## CITY OF FREDERICKSBURG

### PLANNING AND ZONING MEETING AGENDA WEDNESDAY, JANUARY 4, 2023, ~ 5:30 P.M. LAW ENFORCEMENT CENTER – 1601 E. MAIN STREET

**DATE:** January 4, 2023  
**TO:** Planning and Zoning Commission  
**FROM:** Anna Hudson, Interim Director of Development Services  
**SUBJECT:** EC-2022-06 Entry Corridor review for 1455 E. Main

SITE PLAN OF 111 EAST SCHUBERT STREET FOR  
C.U.P. APPLICATION BY JIMMY REICHENAU

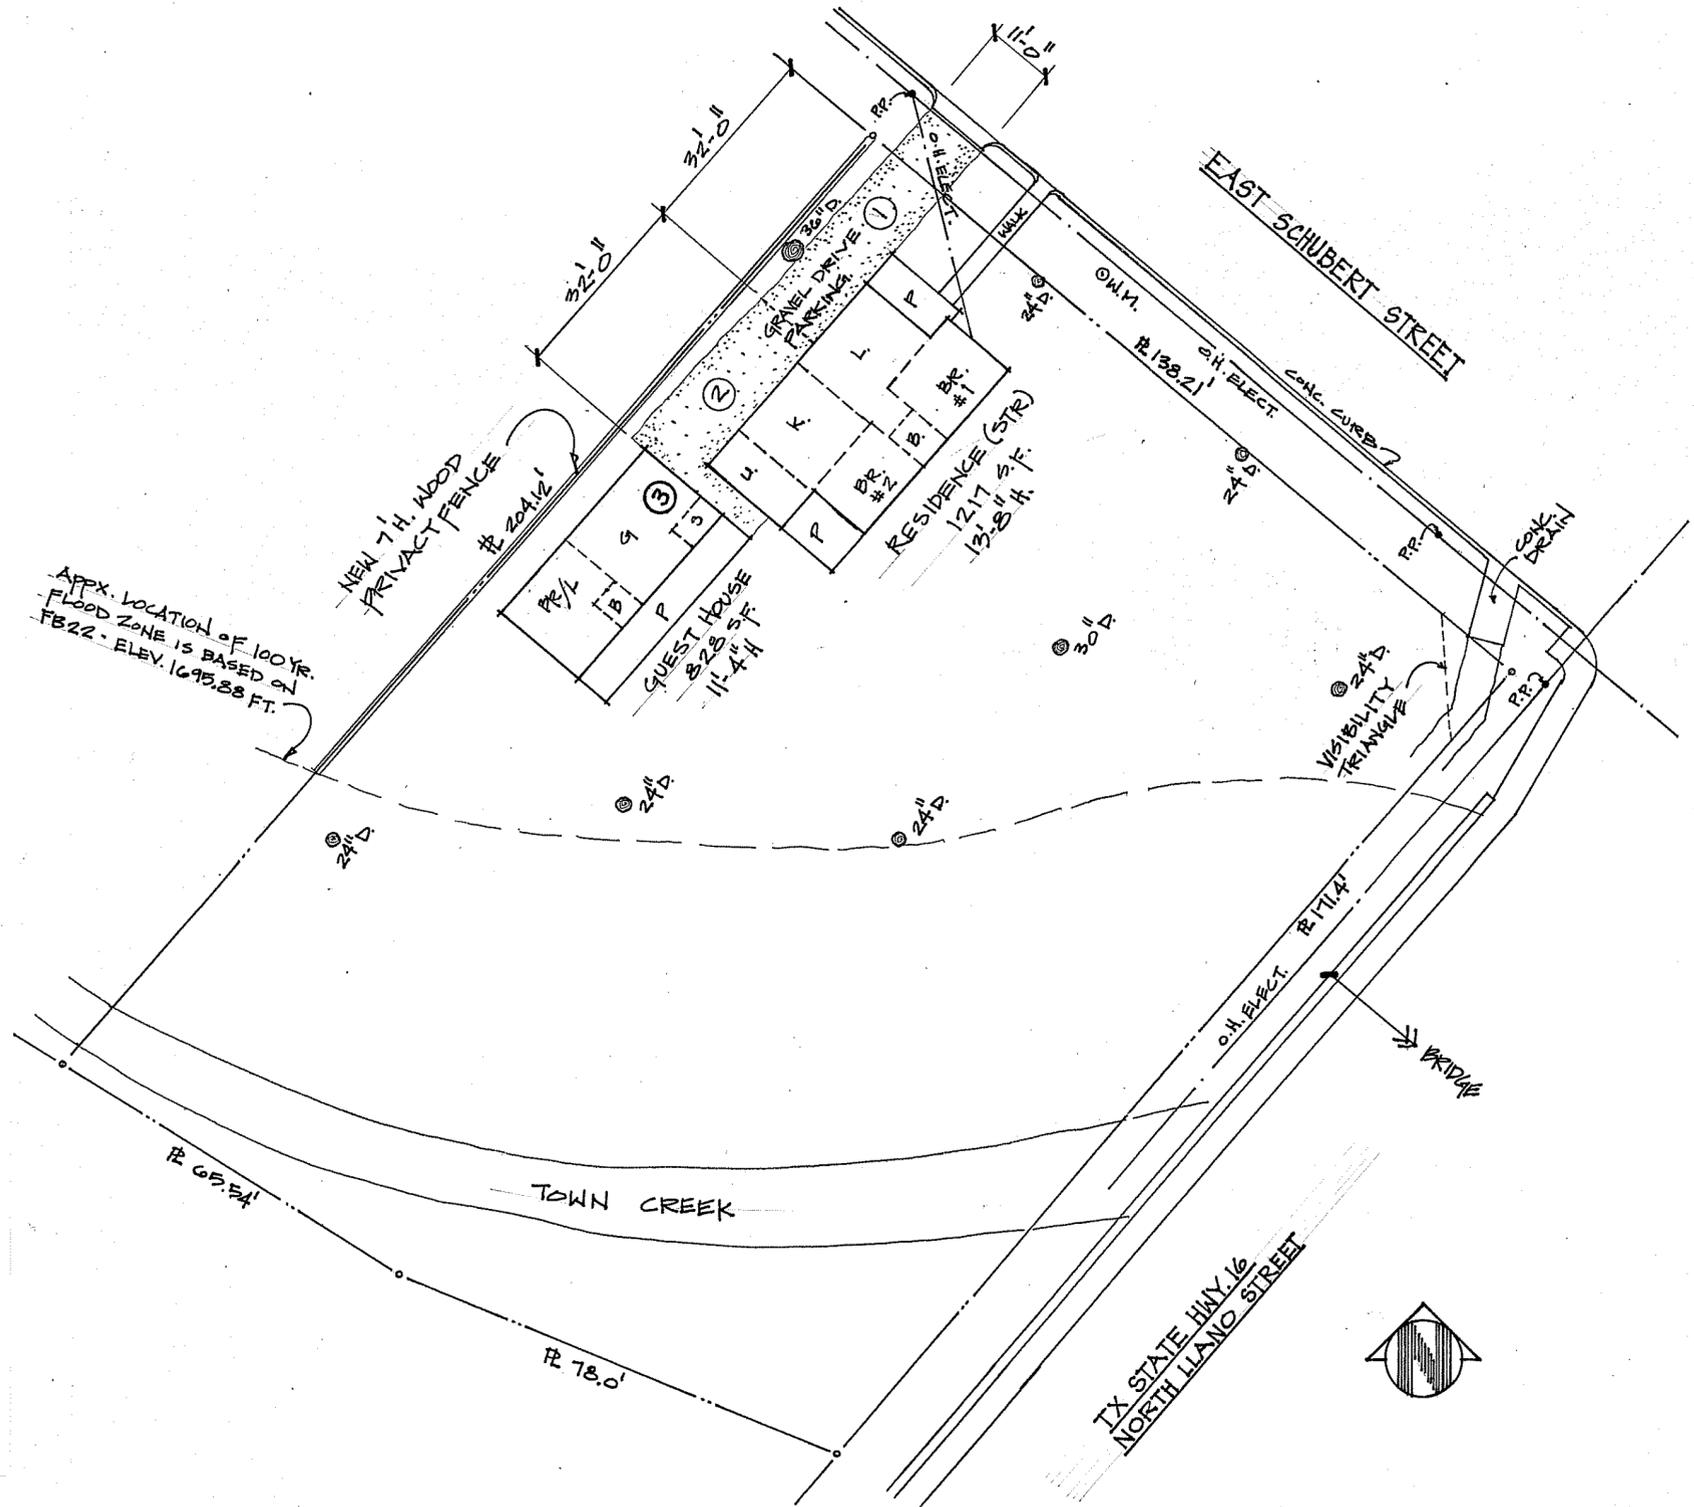
**RE: Z-2230 Review Comments for a CUP to consider an STR-Unoccupied property**

- I am requesting an STR-Unoccupied Permit for the "Residence" at 111 E Schubert Street, as labeled on the resubmitted Site Plan.
- Room arrangements have been indicated on the resubmitted Site Plan.
- Parking Calculations have been updated in the Zoning Summary and the parking spaces have been dimensioned on the resubmitted Site Plan.
- N/A
- A resubmitted CUP Narrative has been updated in accordance with Sec.5.460.
- The note, "All exterior lighting shall be Night Sky compliant", has been provided on the resubmitted Site Plan
- A 7' h. wood privacy fence on the West Property Line has been indicated on the resubmitted Site Plan.

**1455 EAST MAIN STREET  
ENTRY CORRIDOR SITE PLAN**

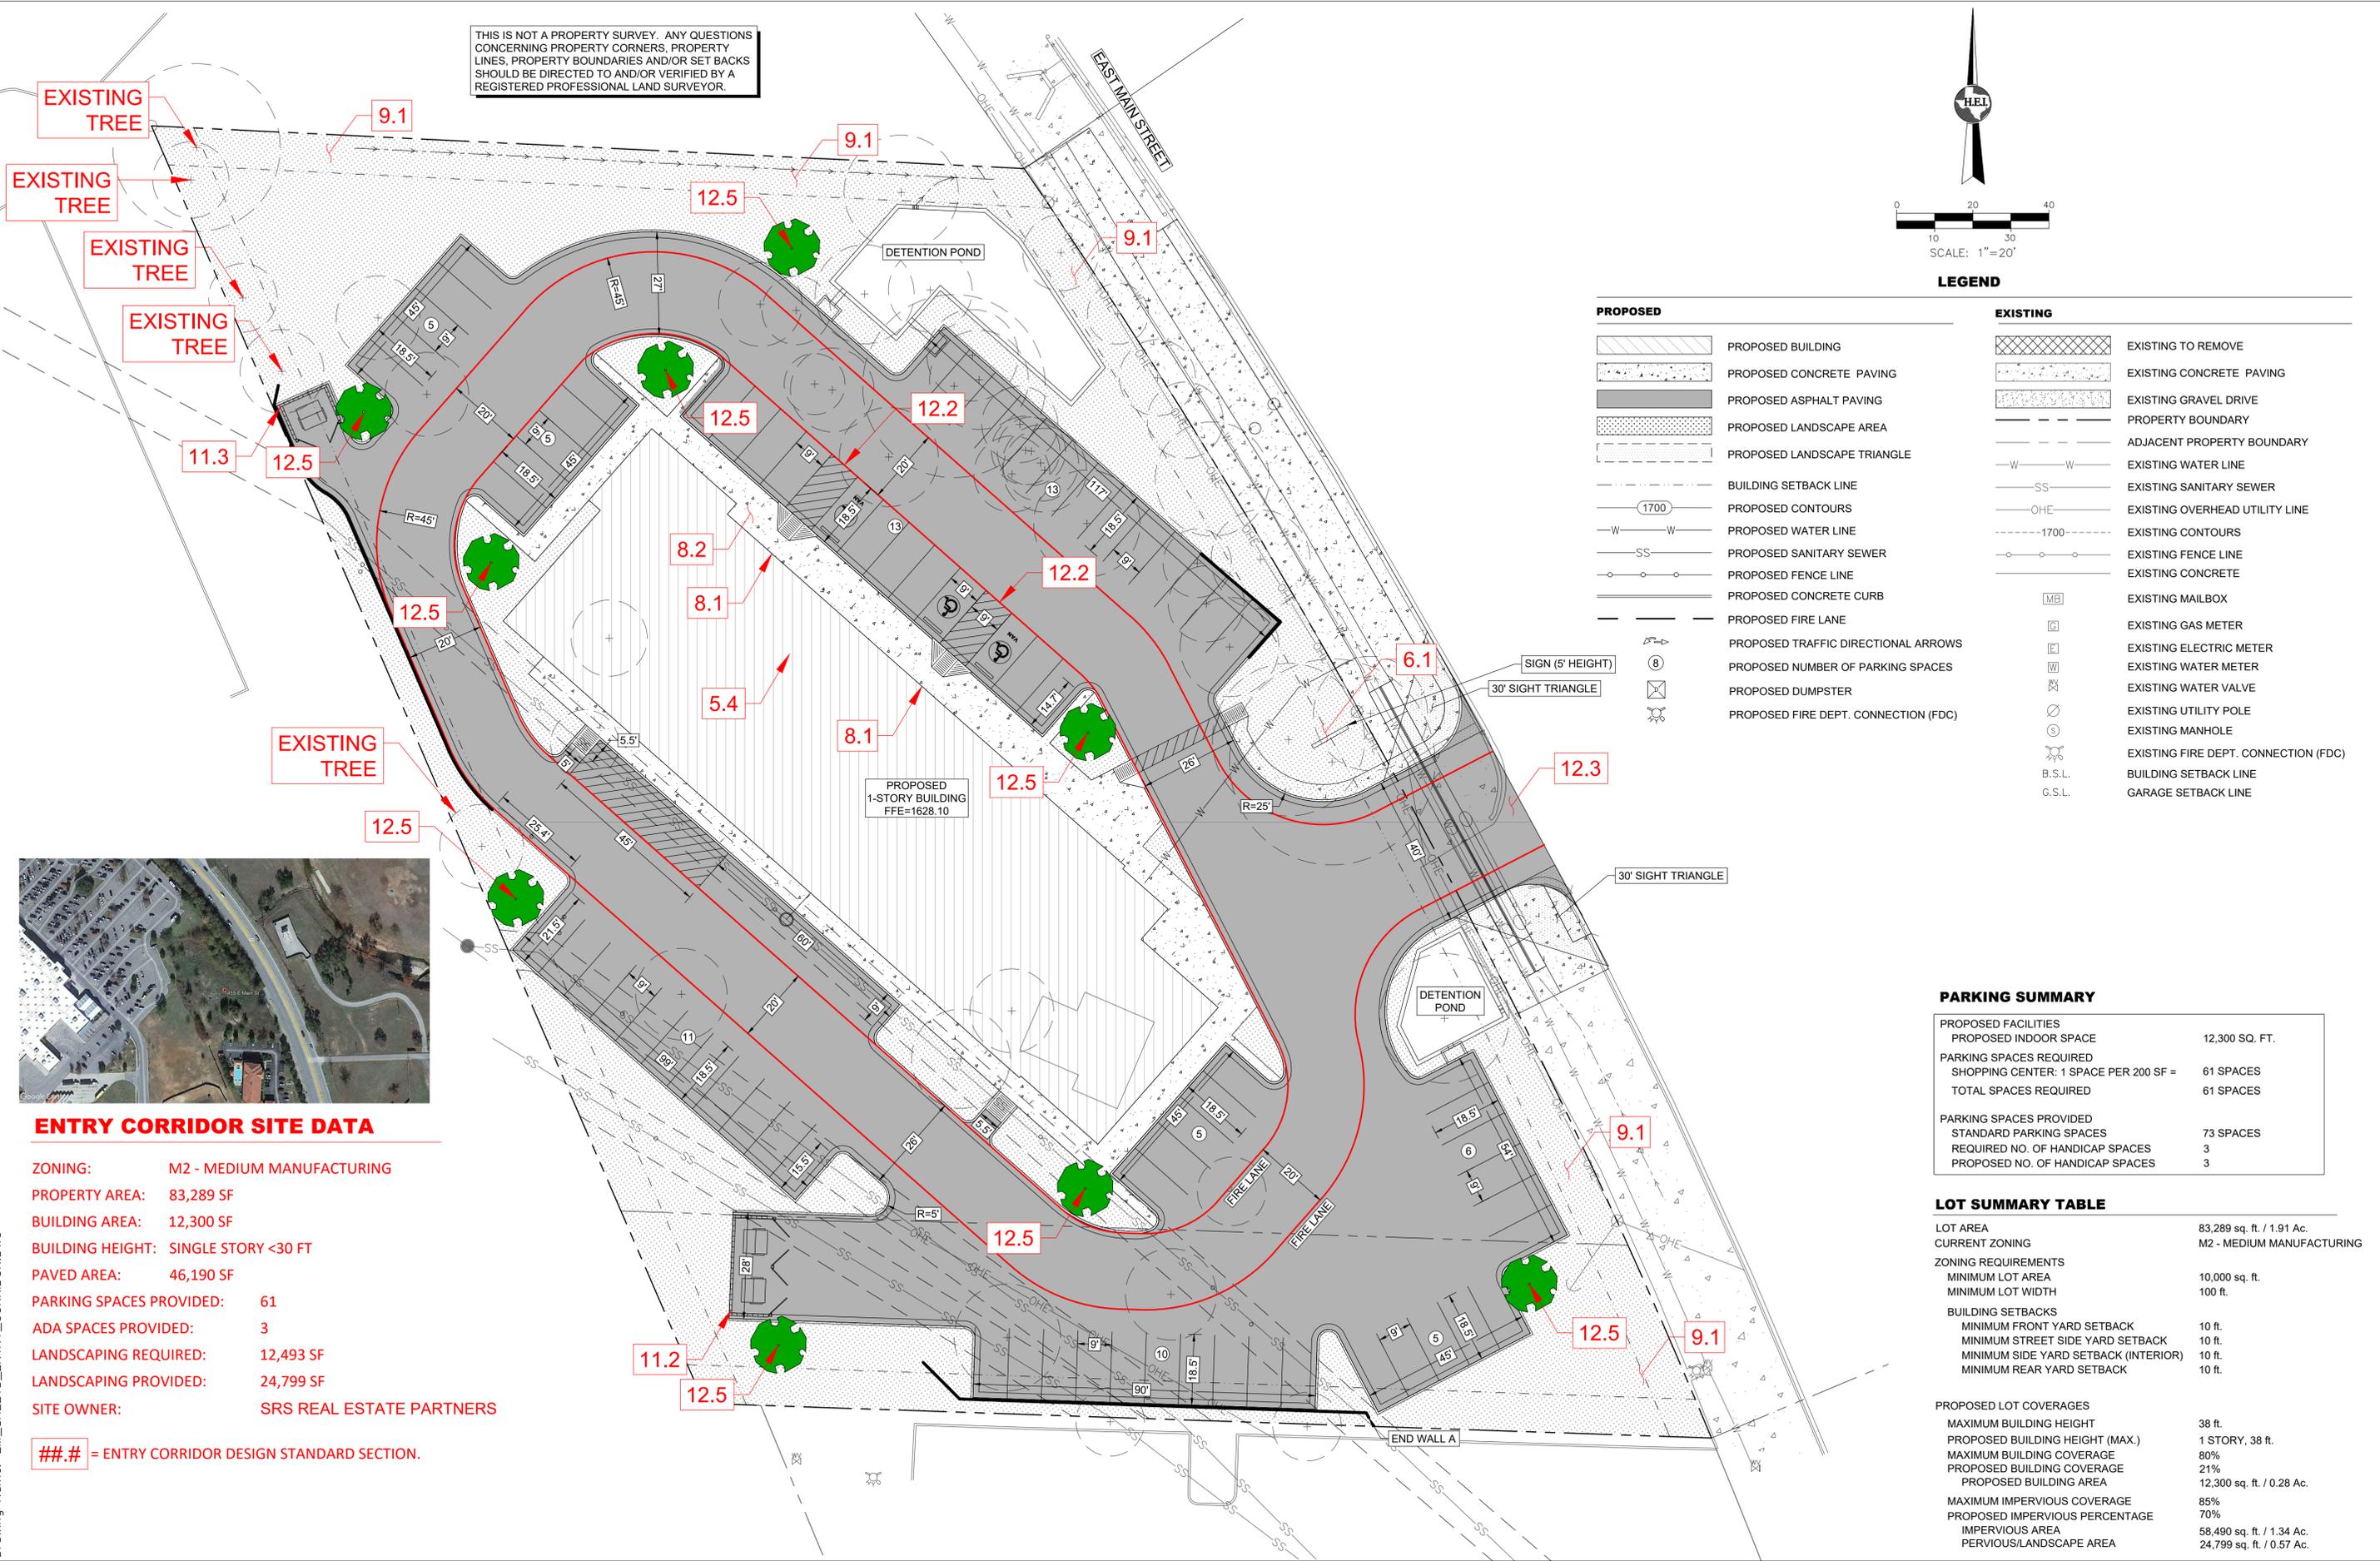
*Staff find the site design to meet intent and requirements. The numerous site limitations including public infrastructure easements limited the ability to bring buildings closer to the street.*

*Staff finds the streetscape to meet most of the intent and requirements.*

A1  
 EXTERIOR ELEVATIONS

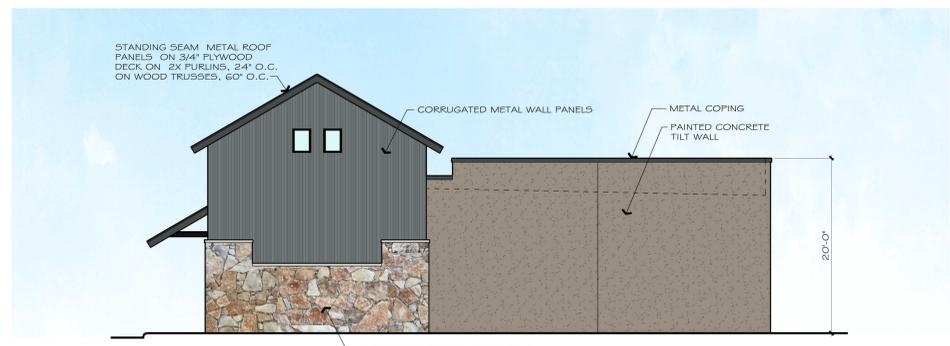
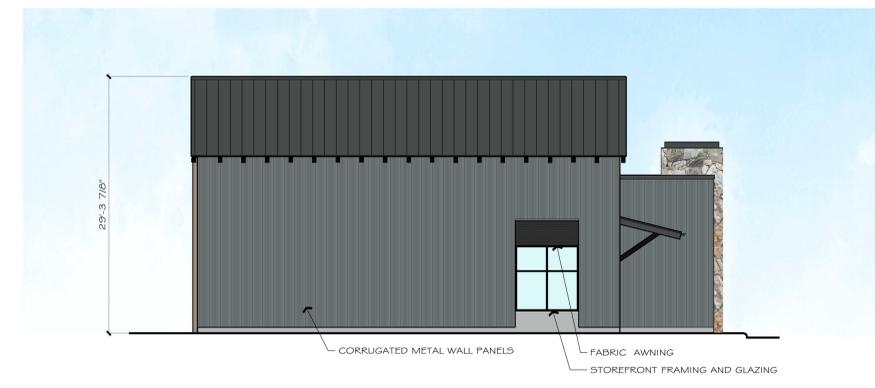
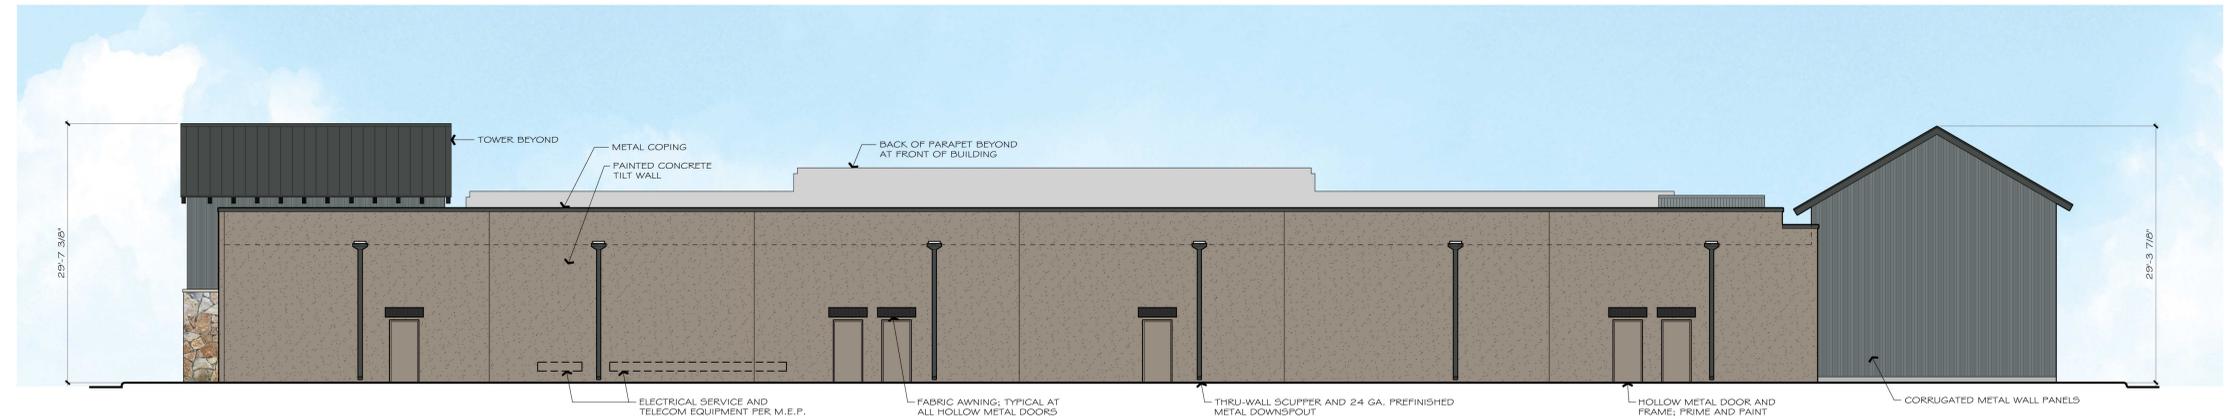
The North elevation facing the Entry Corridor is not black or featureless. It contains differing wall materials, glass, canopies, and awnings. The North elevation facing the Entry Corridor contains clearly defined customer entrances, canopies, overhangs, recesses, projections, distinctive roof forms, and display windows. This will be a multi-tenant commercial building and each storefront of the front façade has a structural canopy or awning that is at least 5 feet in width to provide covered areas for relief from the weather.

*Staff find the architectural features to meet intent and requirements.*

**54% GLASS ON NORTH ELEVATION FACING ENTRY CORRIDOR**  
**WALL-MOUNTED SIGNAGE SHALL CONTAIN A MINIMAL NUMBER OF COLORS, AND BRIGHT COLORS SHALL BE RESERVED FOR ACCENT ONLY**
